Project: 424C01 Cornish Library & Community Center
226 NH-120
Cornish Flat, New Hampshire 03746

RFI #19: Additional MDP In Basement

Re: **Cornish Public Library**
Cornish Flat, New Hampshire
RFI #19
WVA Project No. 23121

ELECTRICAL POWER RISER DIAGRAM
NOT TO SCALE

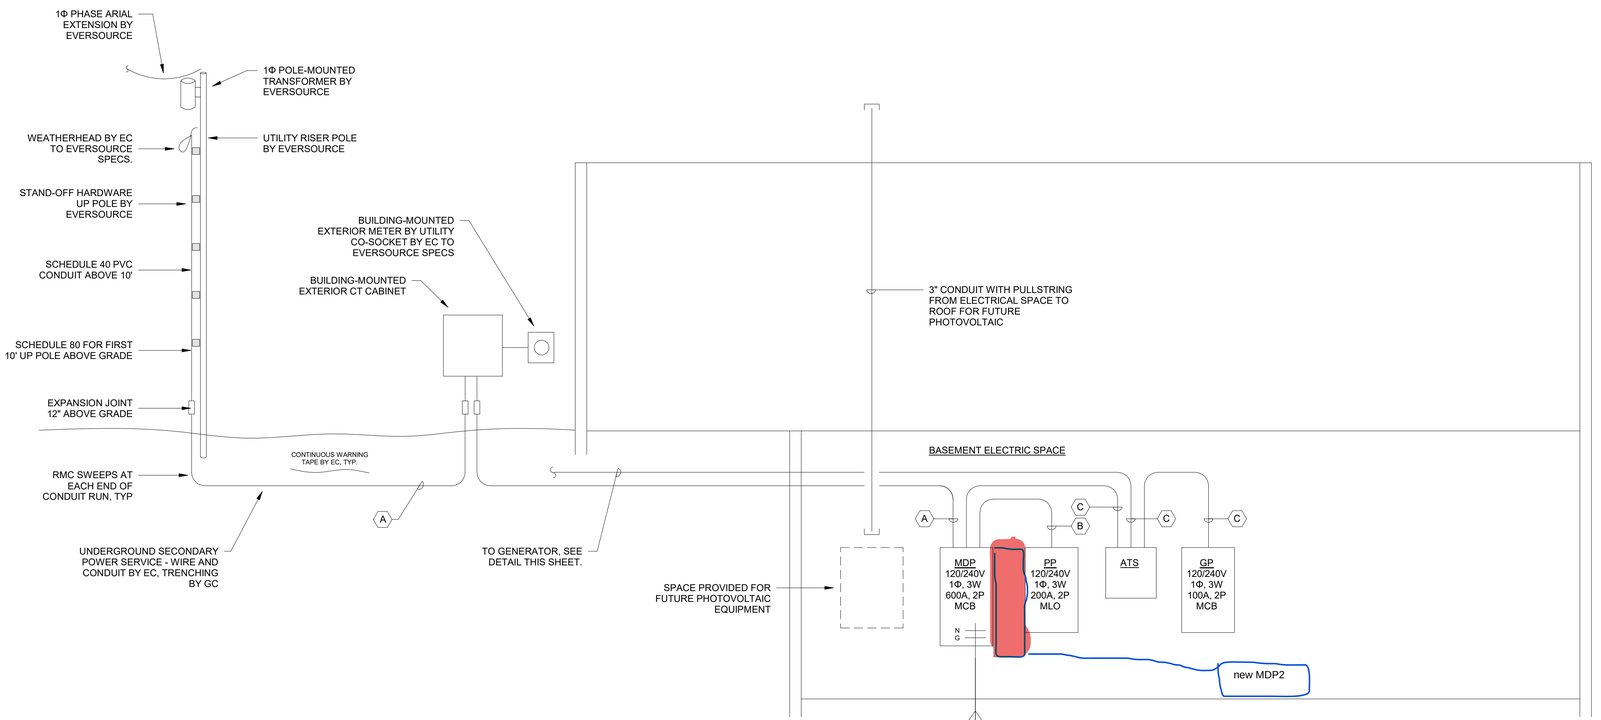
We need to add an additional panel (MDP2) next to MDP 1 because the gear that was spec'd and submitted on will not fit within the height constraints of the smaller basement, original gear package included MDP1 with an 76" tub. the proposed new equipment would be two 72"x20" panel tubs to allow us to move the smaller loads from MDP1 over to MDP2 and keep the larger loads in MDP1 allowing us to use smaller tubs and fit the equipment in the proposed space.

we need to add an additional panel (MDP2) next to MDP 1 because the gear that was spec'd and submitted on will not fit within the height constraints of the smaller basement, original gear package included MDP1 with an 76" tub. the proposed new equipment would be two 72"x20" panel tubs to allow us to move the smaller loads from MDP1 over to MDP2 and keep the larger loads in MDP1 allowing us to use smaller tubs and fit the equipment in the proposed space

Refer to markup on following page.

In response to RFI regarding the panel clearance space within the basement, we offer the following. We understand that the 76" tall panel MDP is too large to fit within the basement, and it has been proposed replacing the design panel with a 72" double tub panel and reorganizing the circuits within. This proposed solution is acceptable, and we find no issue with this change.
